收件者: tpbpd/PLAND
副本: Jet Sze Jet CHEUNG/PLAND; Yen PY LEUNG/PLAND
主旨: Fw: S. 16 Planning Application No. A/YL-KTN/1155 - Departmental
Comments
附件: AYL-KTN 1155 DS 20250917.pdf

A/YL-KTN/1155 的擬議渠務建議詳細

S.16 Planning Application No. A/YL-KTN/1155

<p><u>Appendix 7.2</u></p> <p>Catchment Area (Application Site)</p>	<p>Location: D.D. 109 Lot 655 (Part) OZP: S/YL-KTN/11 District: Kam Tin North Zoning: Agriculture</p>	<p>Project: Proposed Temporary Holiday Camp with Ancillary Facilities and Associated Filling of Land For a Period of 3 Years</p>	<p>Around 5,699.6 m²</p> <p>Scale: 1:750 @A4</p>	<p>Drawing No.: 7.2-1</p> <p>For Identification Only</p> <p>Date: 15/07/2025</p>
---	---	--	---	--

Check The Capacity of Existing 1.4m (W) x 0.7 (D) Open Channel

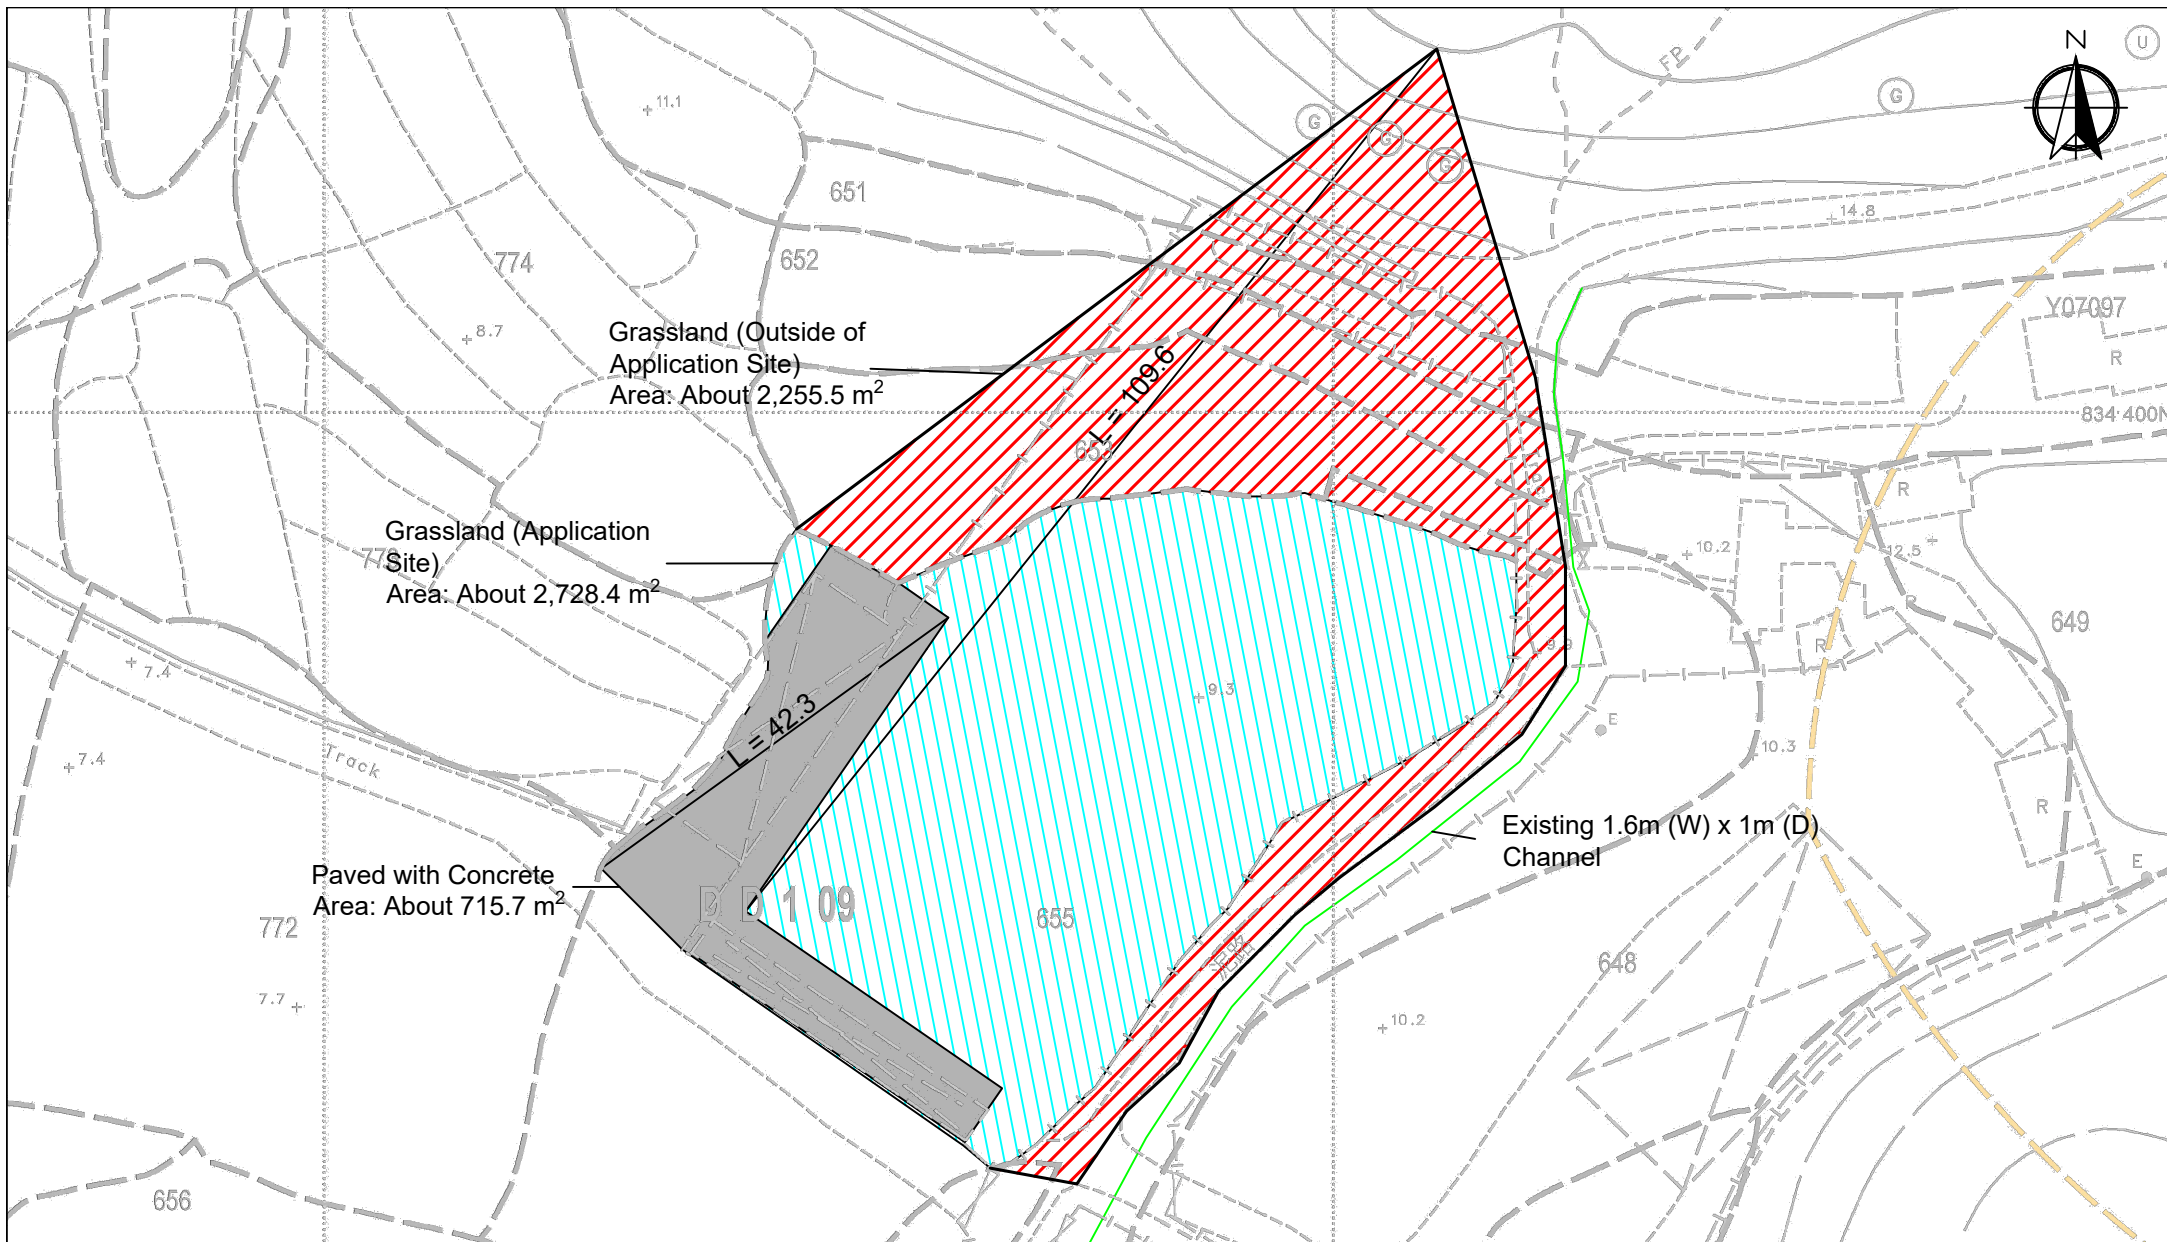
<i>overland flow intercepted from the adjacent lands.</i>	
B (v)	<i>The applicant should clearly indicate the existing drainage facilities on the proposed drainage plan. Since there is no record of the said discharge path, site photos of existing drainage facilities including the discharge point (e.g. existing 1.5m (W) x 0.7m (D) channel shown on the submitted drawing (No.: 7-01) and its downstream drainage facilities and existing 1.6m (W) x 1m (D) channel shown on the submitted drawing (No.: 7.2-1) should be provided in order to demonstrate the presence and reflect condition of the existing drainage system.</i>	The photos of the existing channel, please see appendix 7.3 and 7.4.
B (v i)	<i>The applicant should demonstrate the existing facilities to be discharged to have sufficient capacity to cater for any additional flow generated due to the subject application.</i>	Please see calculations for the changes. Hydraulic calculation checking the existing 1.4m (W) x 0.7m (D) open channel is provided.

Where R	= A/P = 0.35 m	A = 0.98 m ²
		P = 2.8 m
n	= 0.05 s/m ^{1/3}	(Table 13 of Stormwater Drainage Manual)
S _f	= 0.01

Therefor V = 0.35^{2/3} * 0.01^{0.5} / 0.05
 = 0.99 m/sec

Maximum Capacity (Q_{max})
 = 0.8V * A
 = 0.795 m³/sec
 = 0.795 * 60000
 = 47,700 lit/min
 > Q_{total}

The Existing Drainage has enough capacity.
